STATE	PROJECT	SHEET NO.
HI	HI STP H1(1)	T1

DRAINAGE PLAN & PROFILE

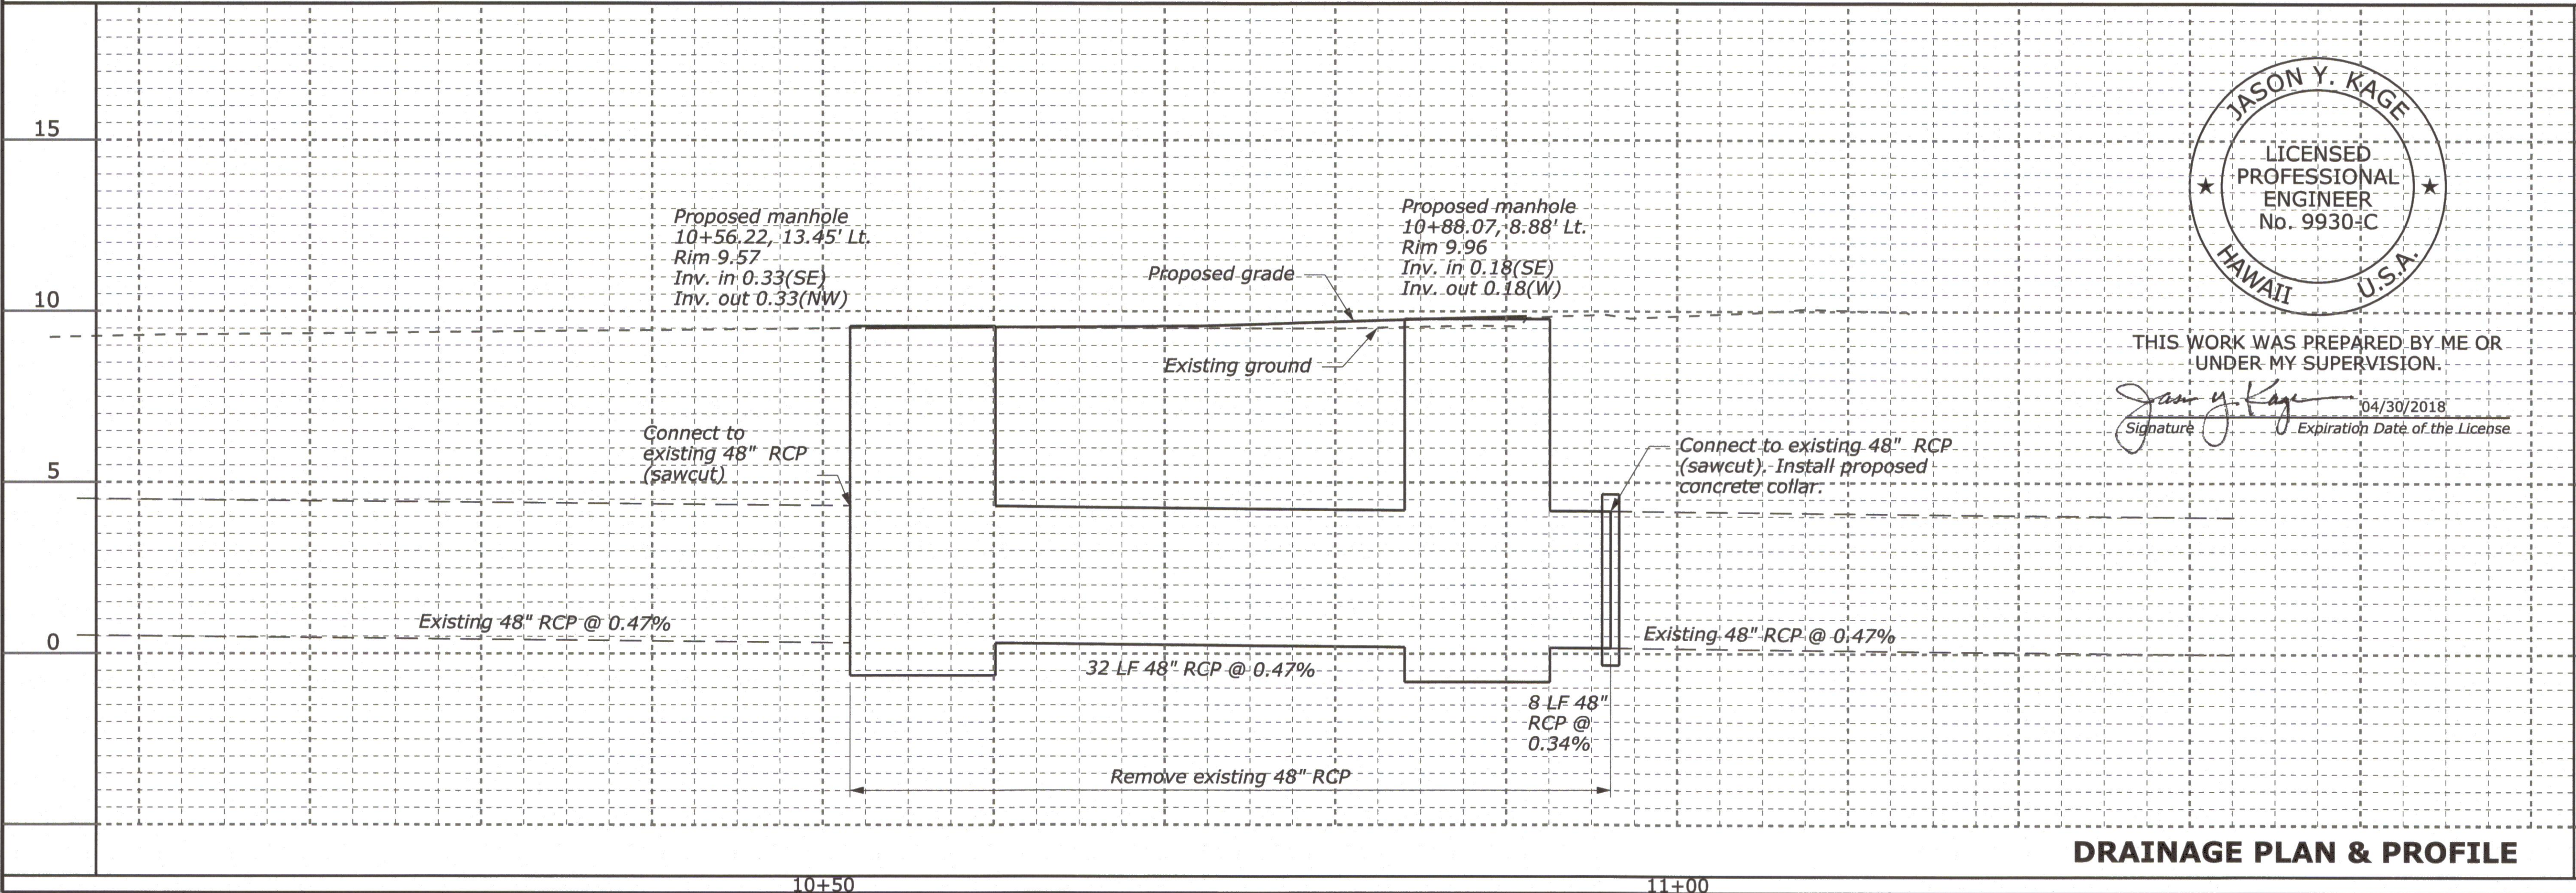
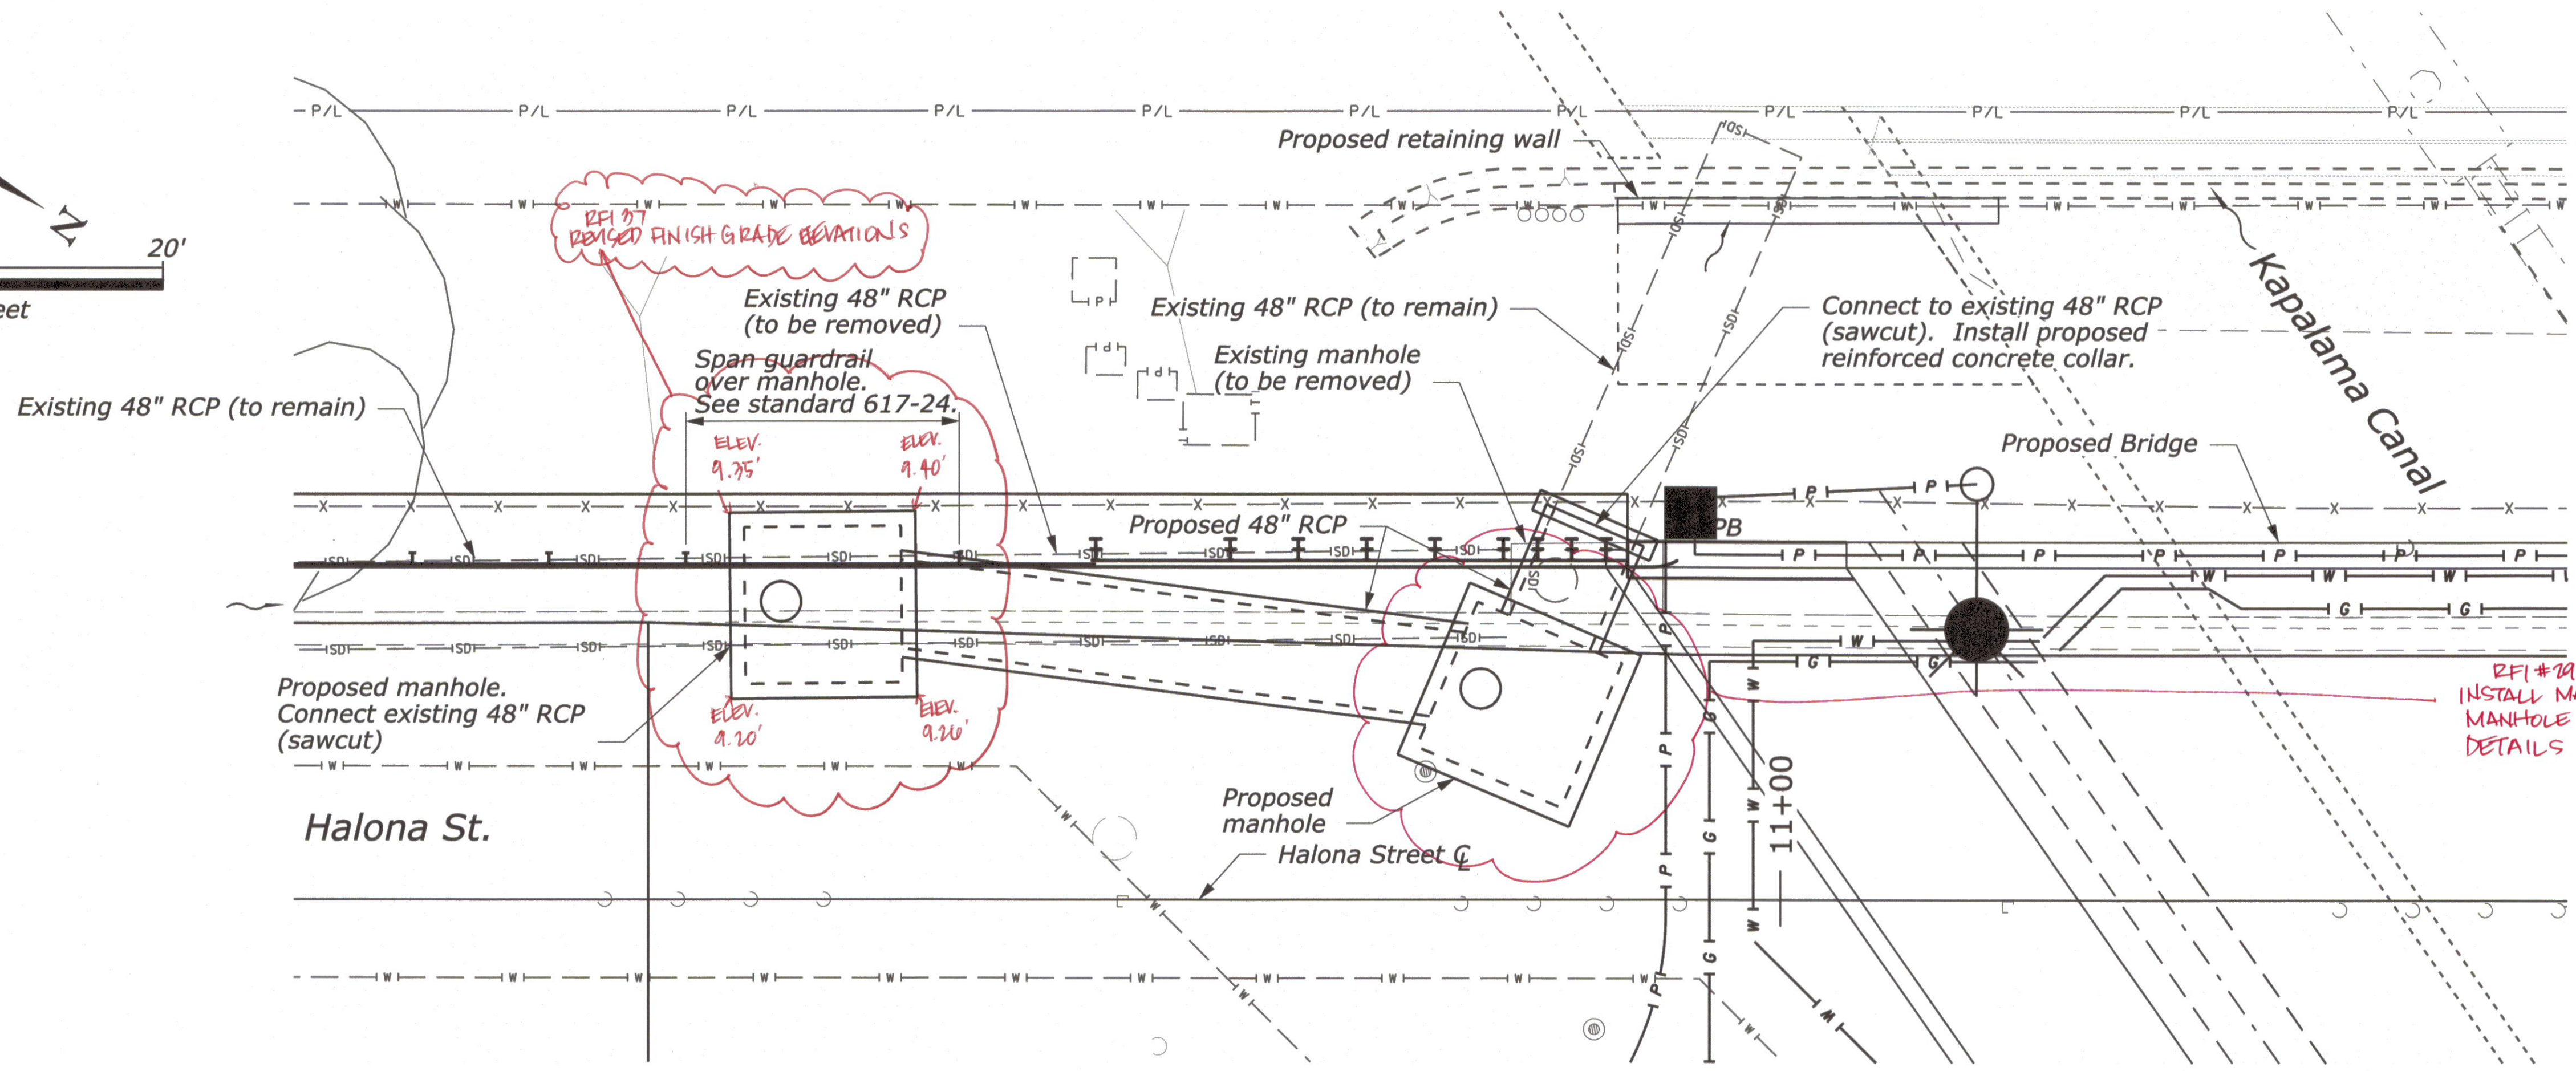
RFI #19: INSTALL MANHOLE BOX LID AND MANHOLE RISER PER STANDARD DETAILS M-604-20 (SHEET NO. T0-1, T0-2, T0-3).
